ADDRESS: 700-02 AND 704 CHESTNUT ST

Proposal: Demolish building, construct addition

Review Requested: In Concept

**THE MINUTES OF THE 720TH STATED MEETING OF THE
PHILADELPHIA HISTORICAL COMMISSION**

1 CONTEXT MASSING VIEW

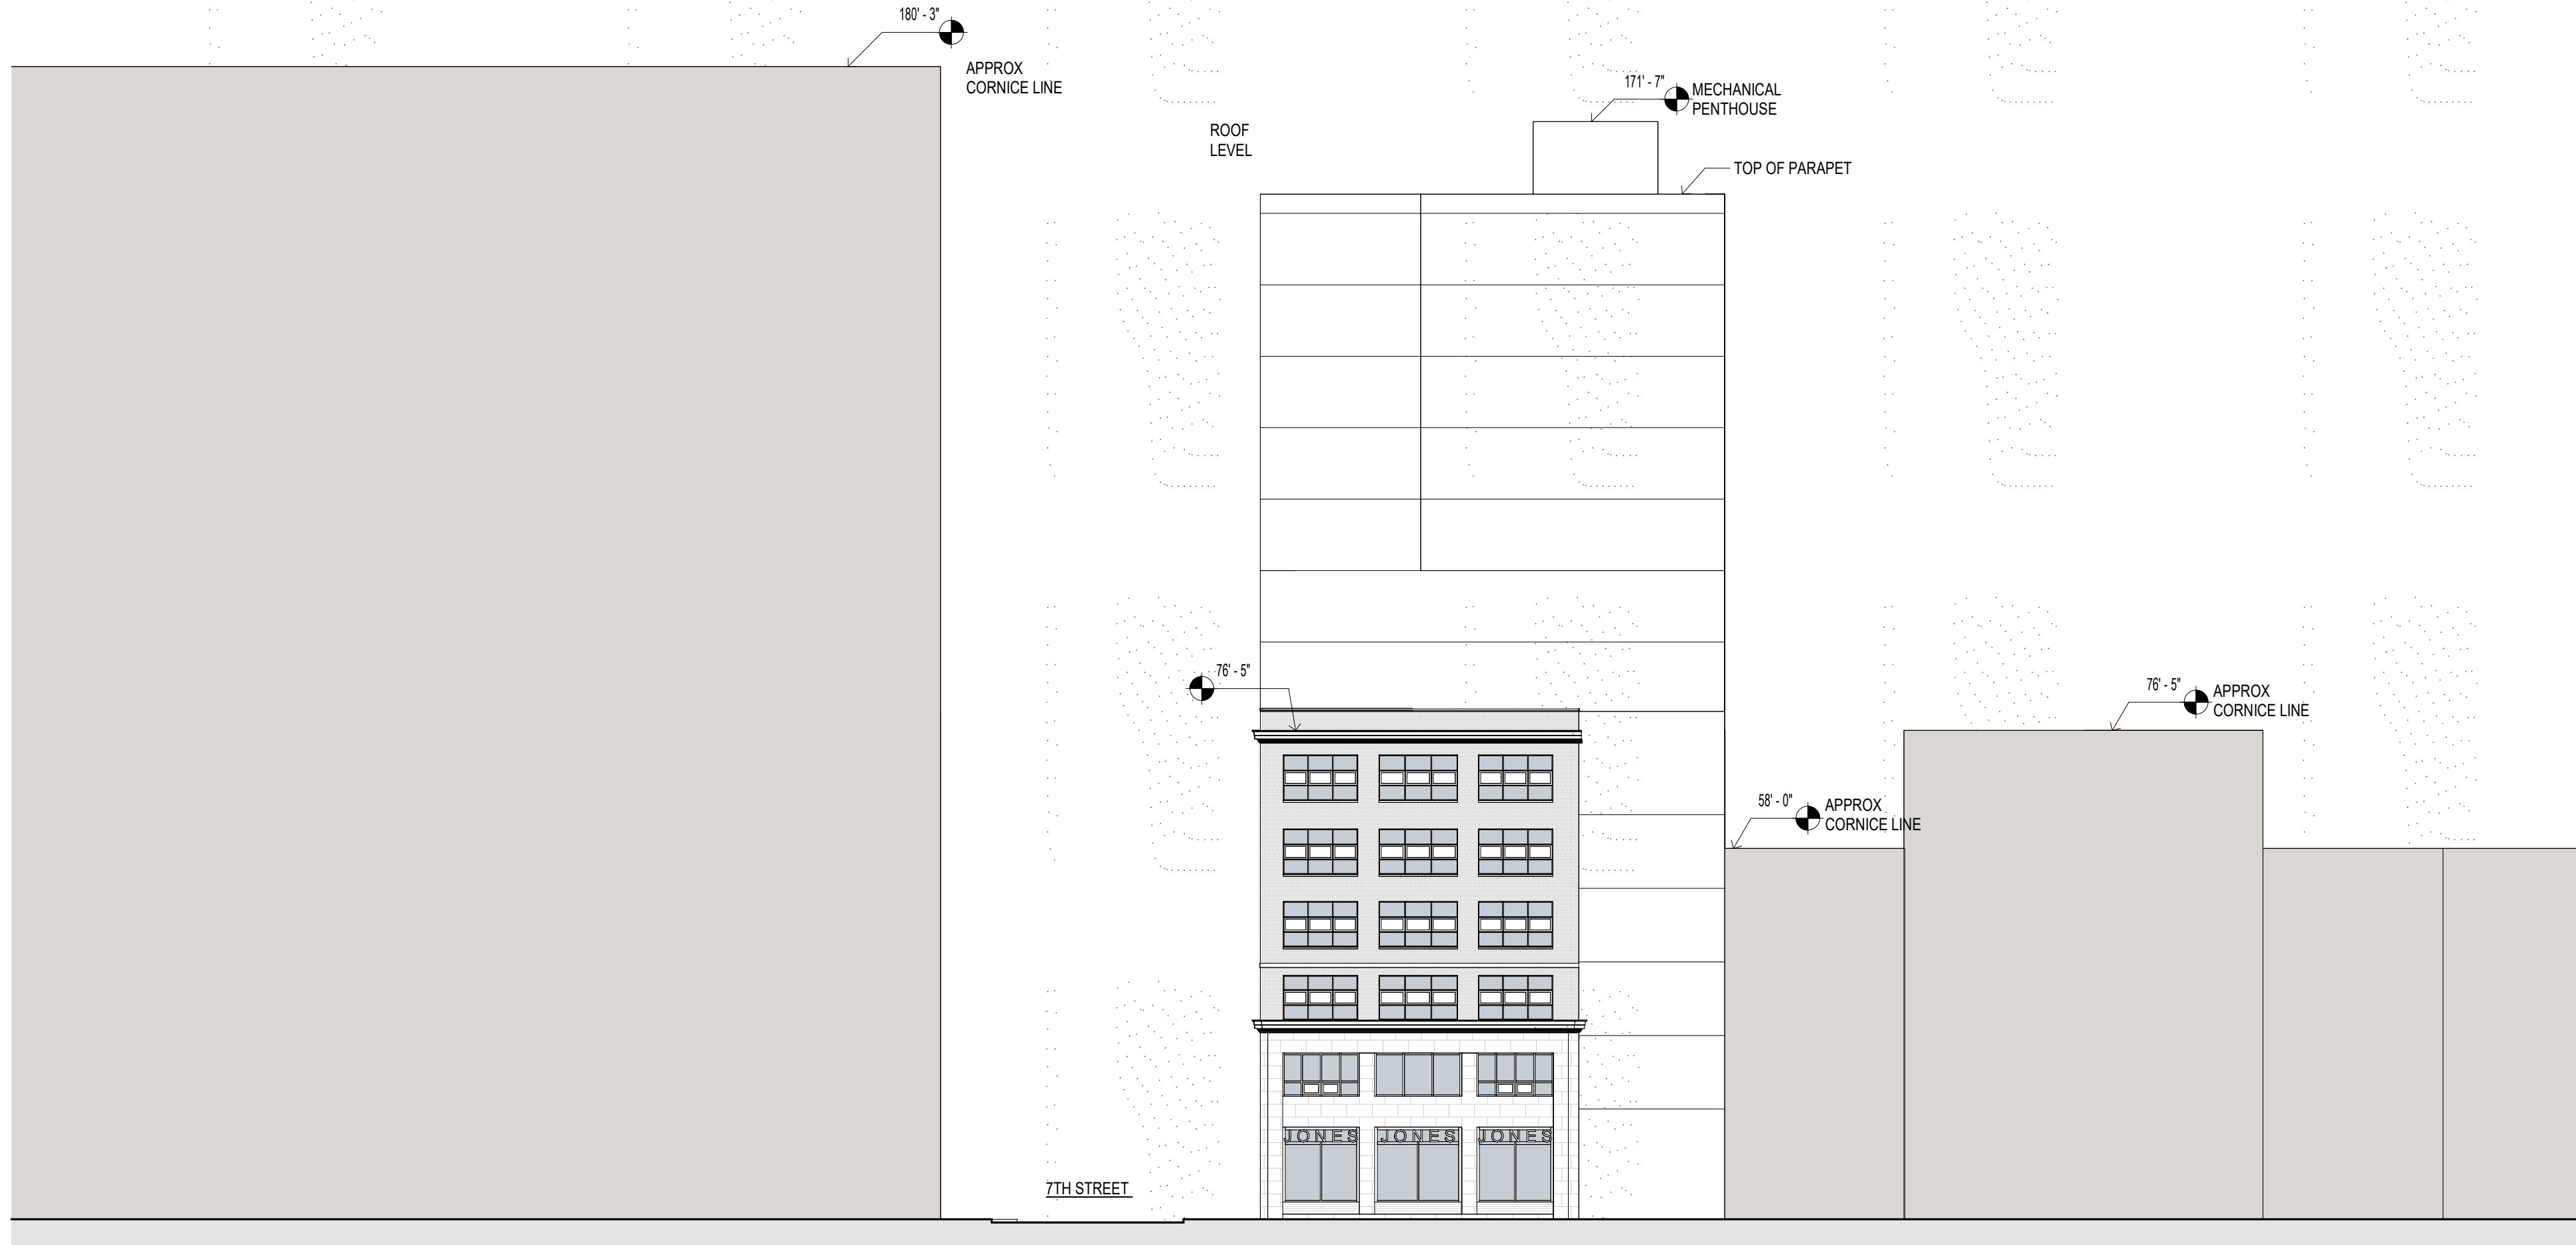
- Mr. McCoubrey suggested that they include the adjacent buildings in their drawings so that the Historical Commission can understand the scale and context. He stated that a large setback will be needed at Chestnut Street. He added that the proposed height is much too tall.

PROPOSED
NEW
ELEVATIONS

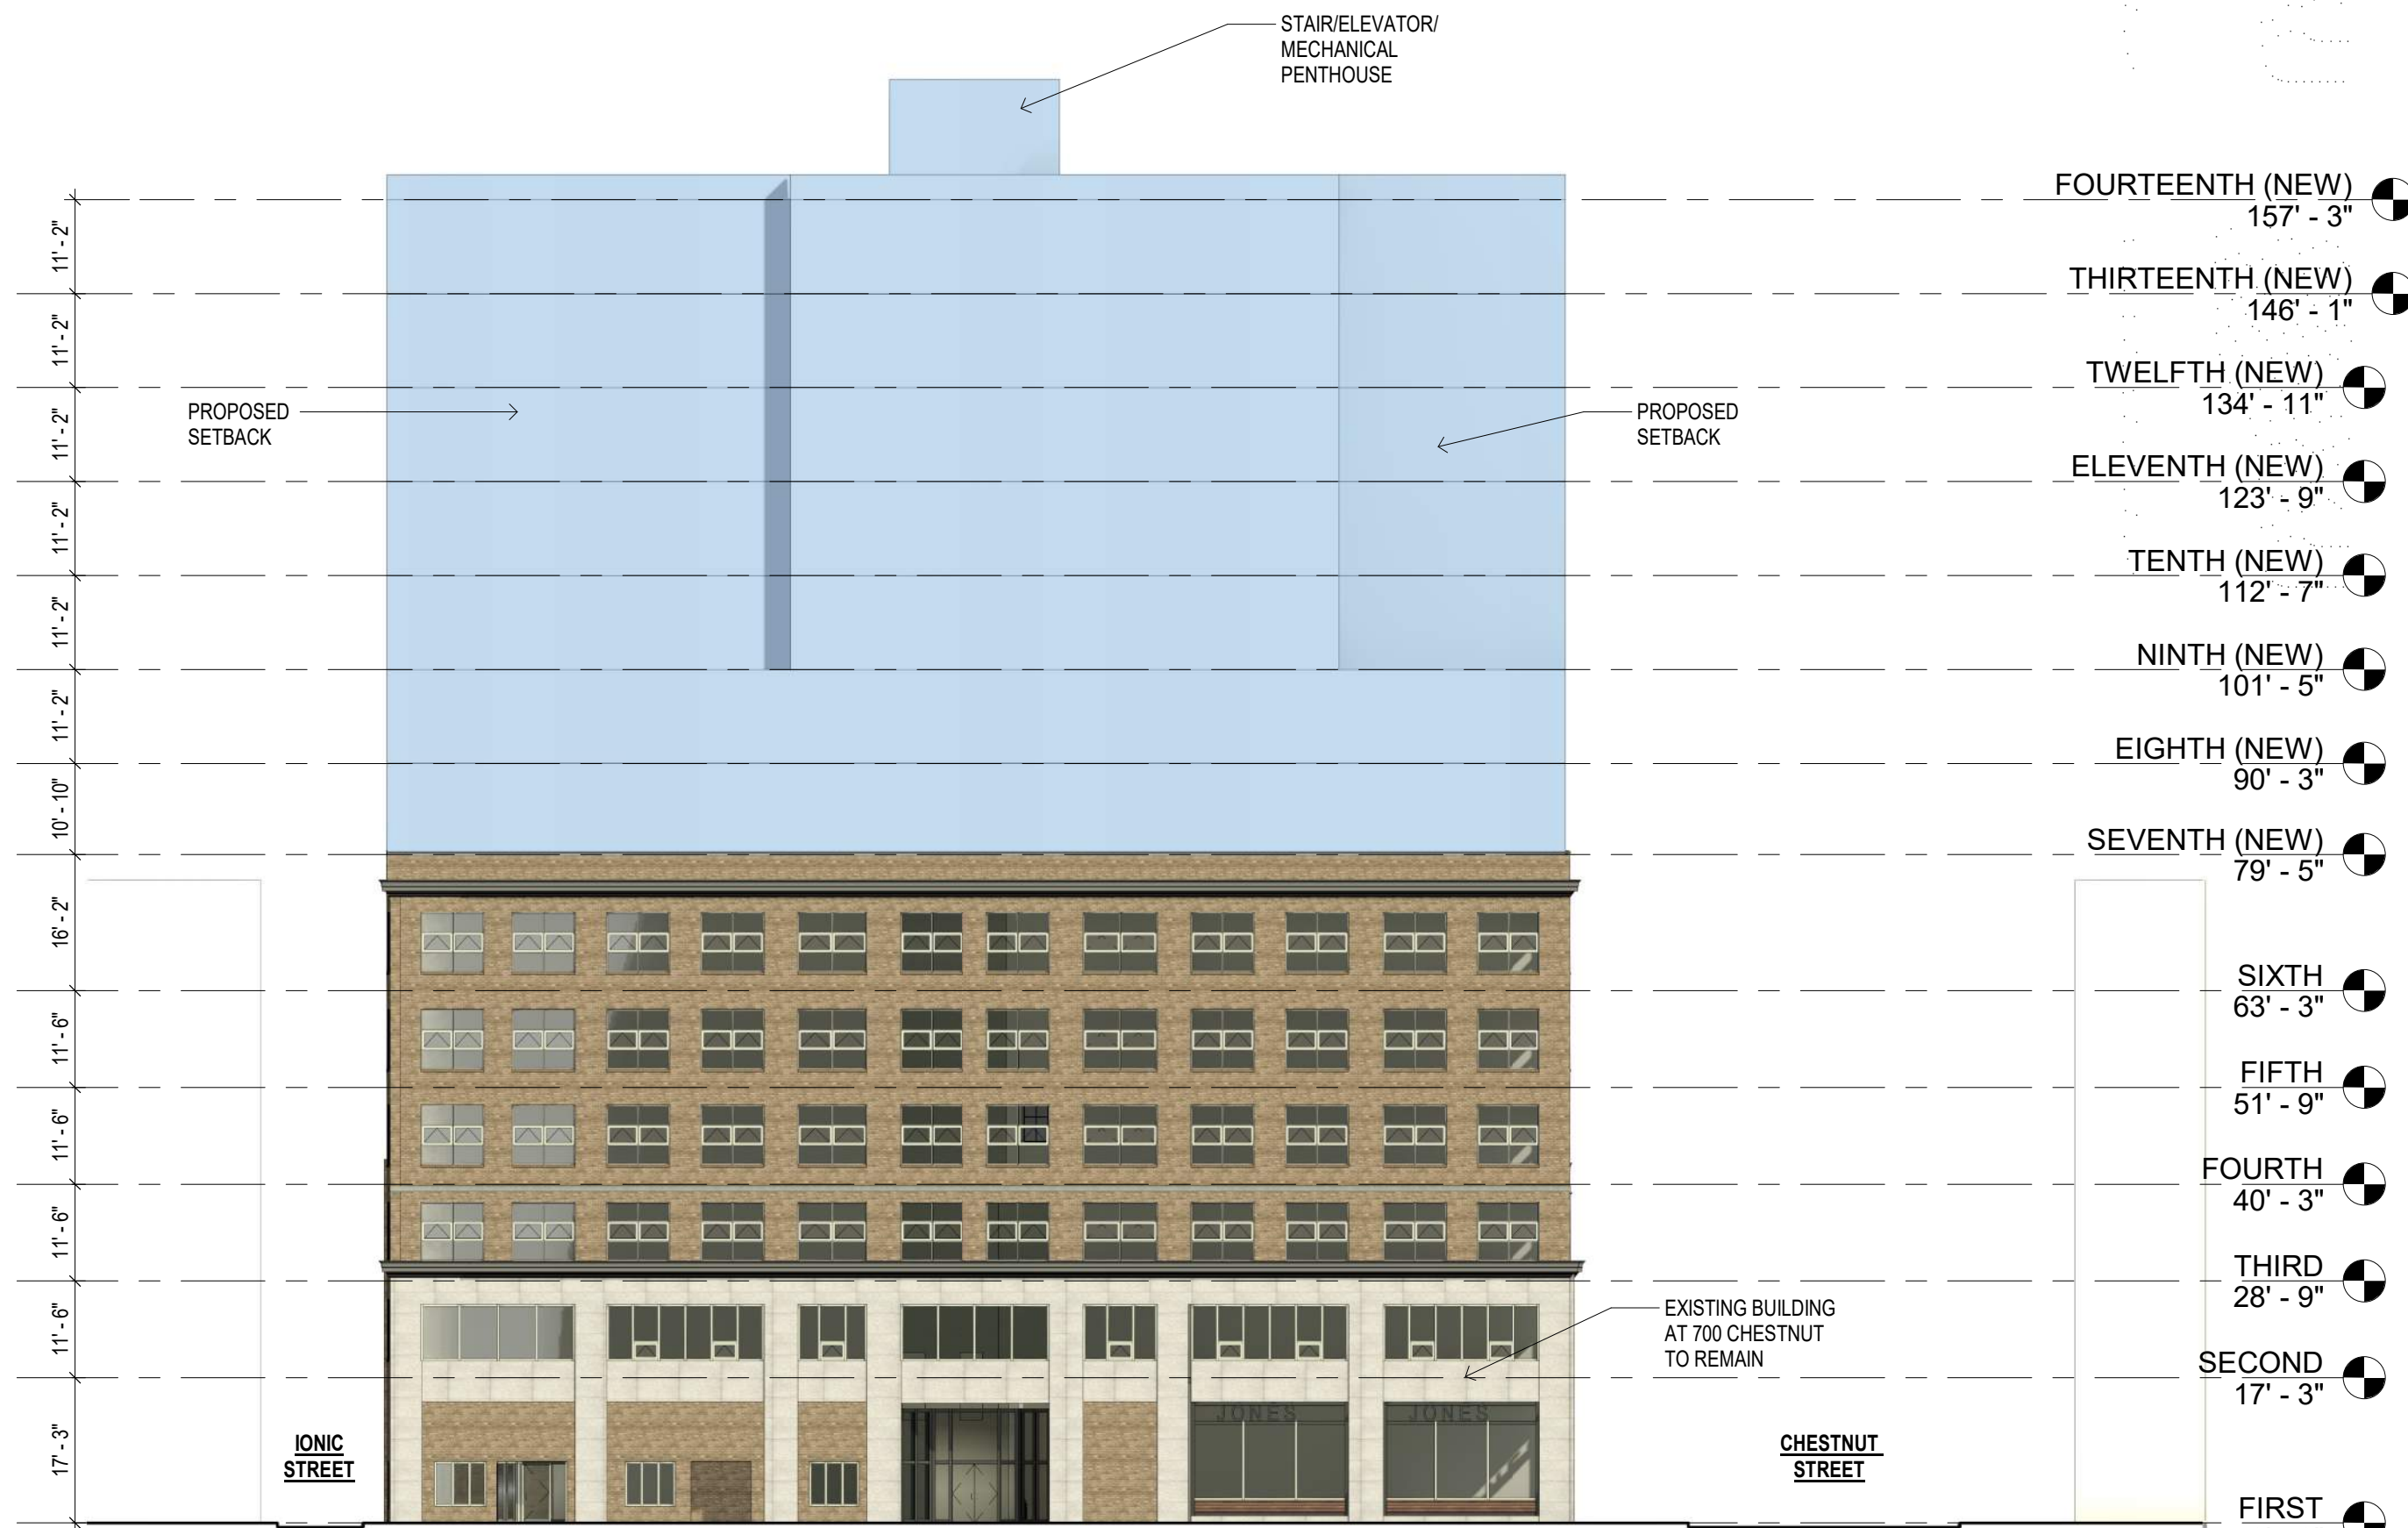
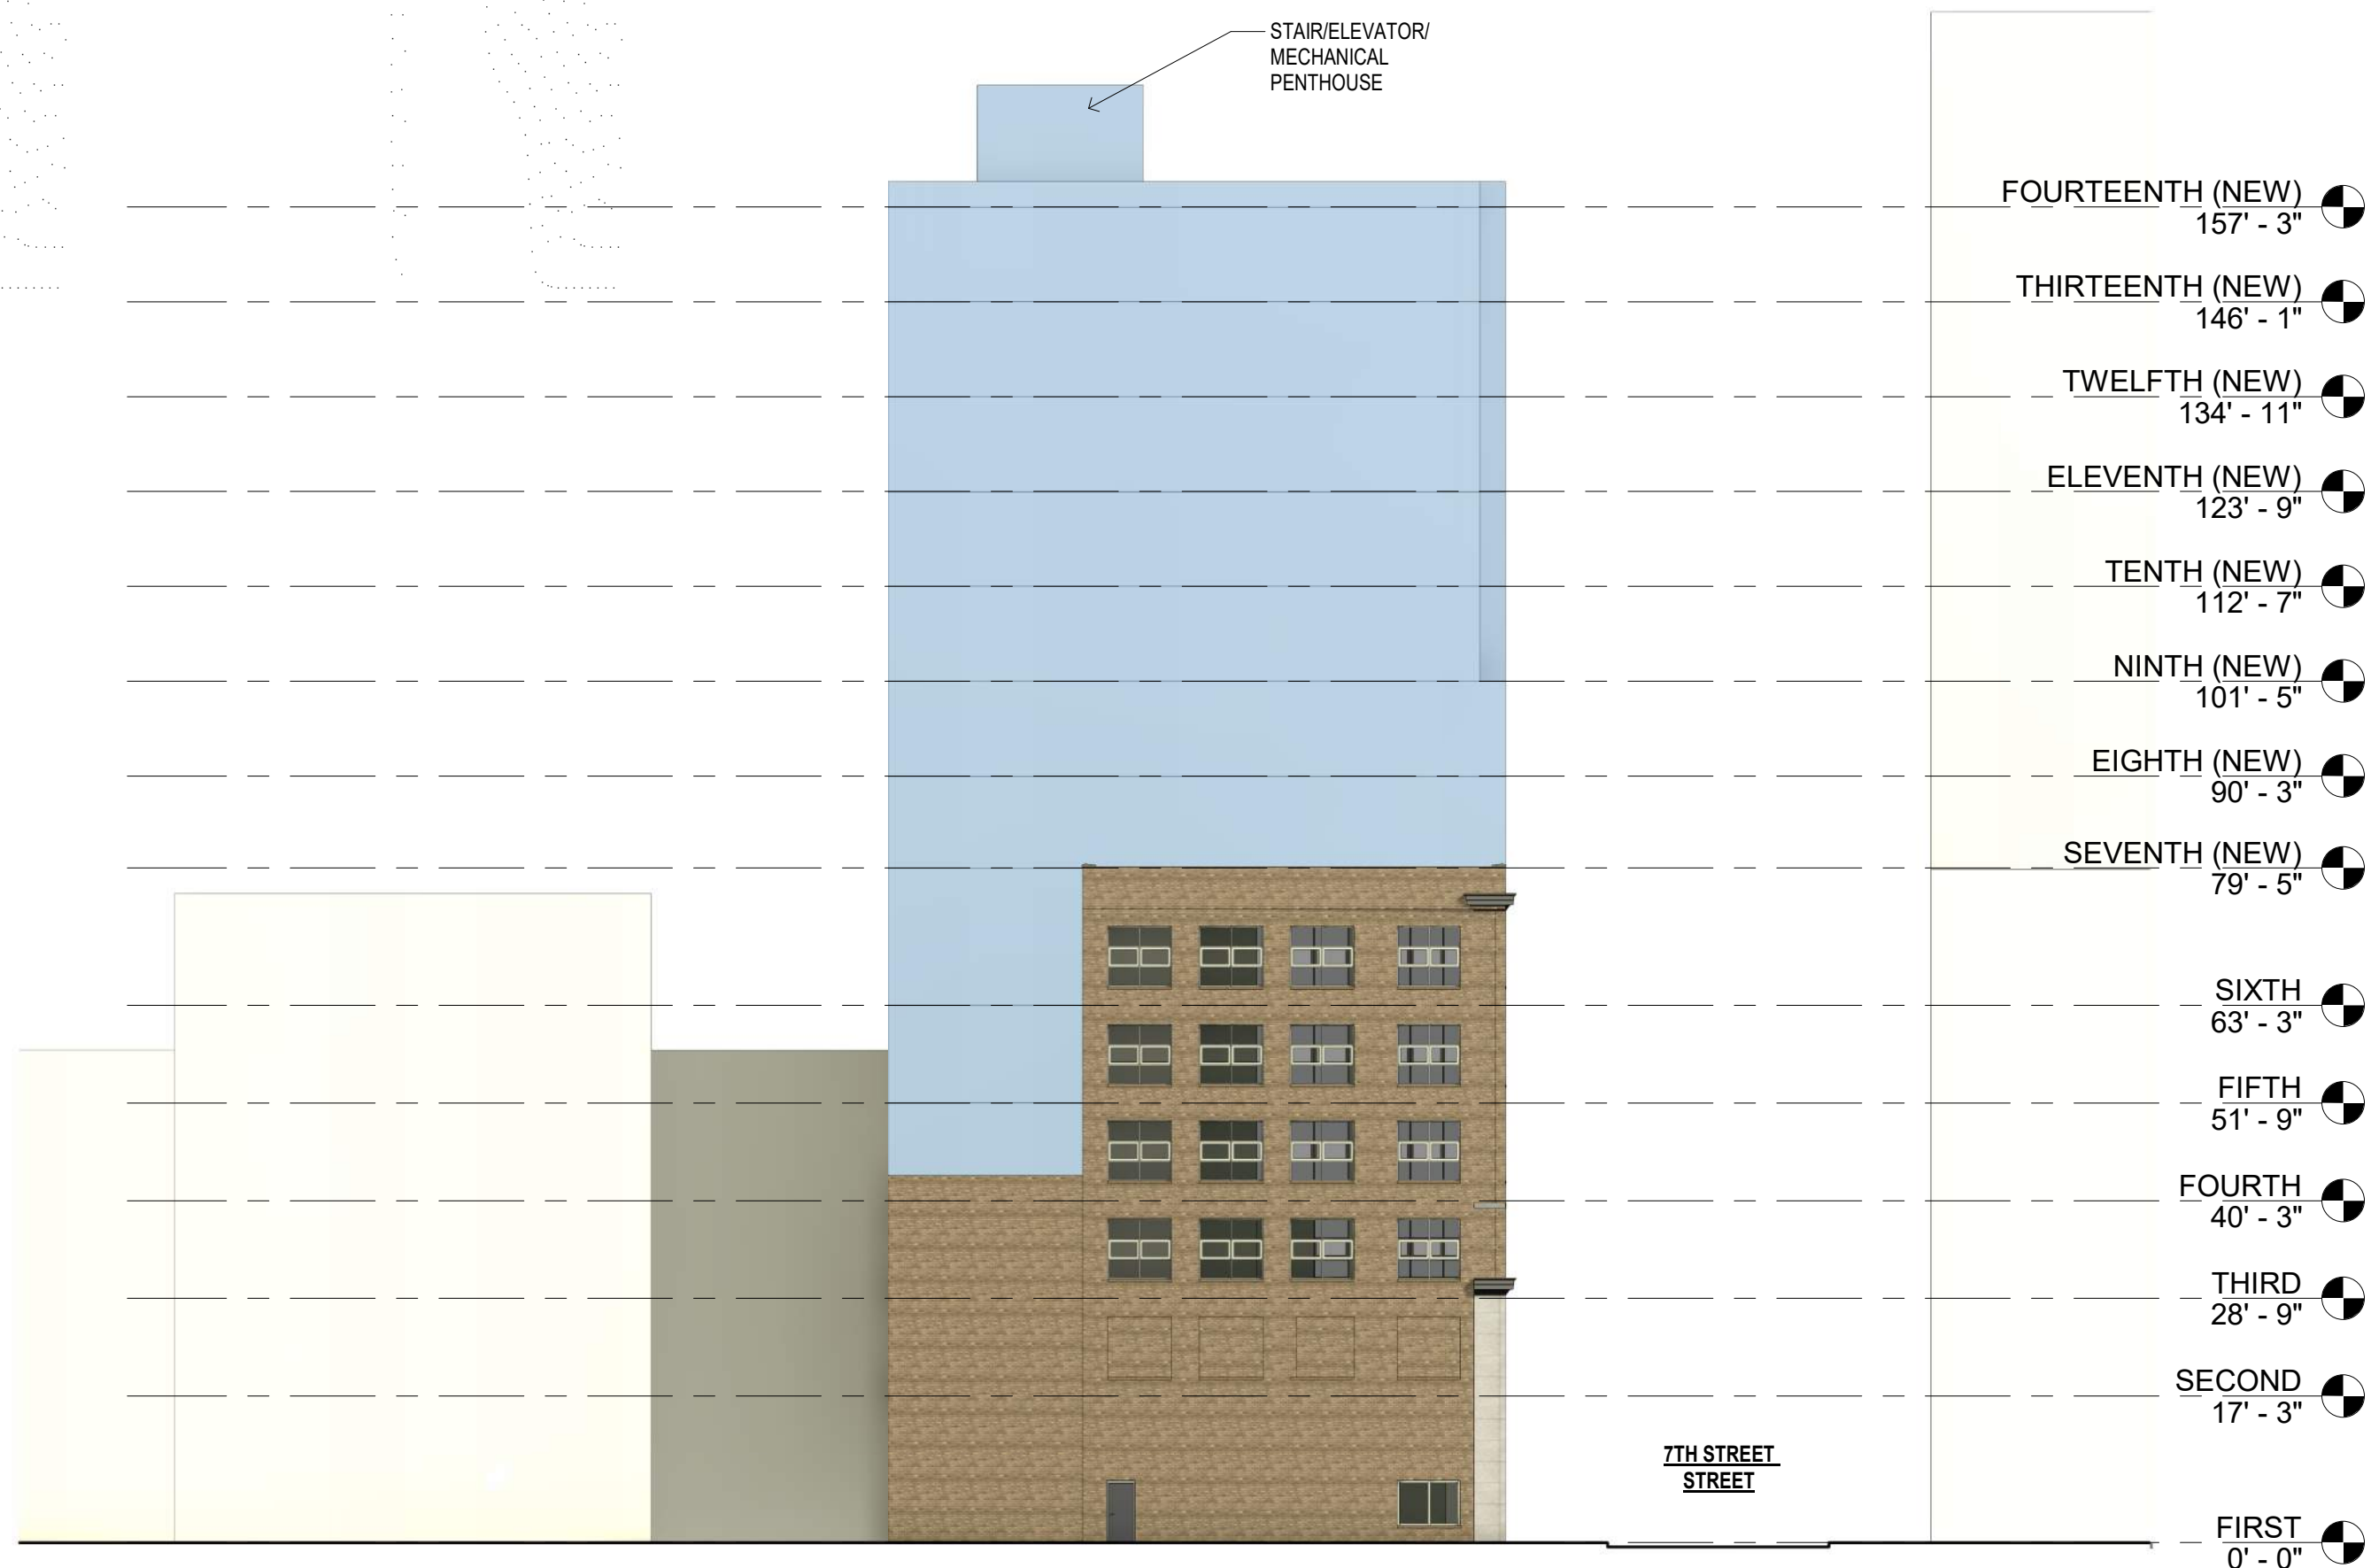
- Mr. McCoubrey asked about the appearance of the west-facing wall.
 - Mr. Schultz displayed an elevation drawing and explained that it would be a party wall with some setbacks and windows. He stated that he could add articulation to the blank sections of the wall.
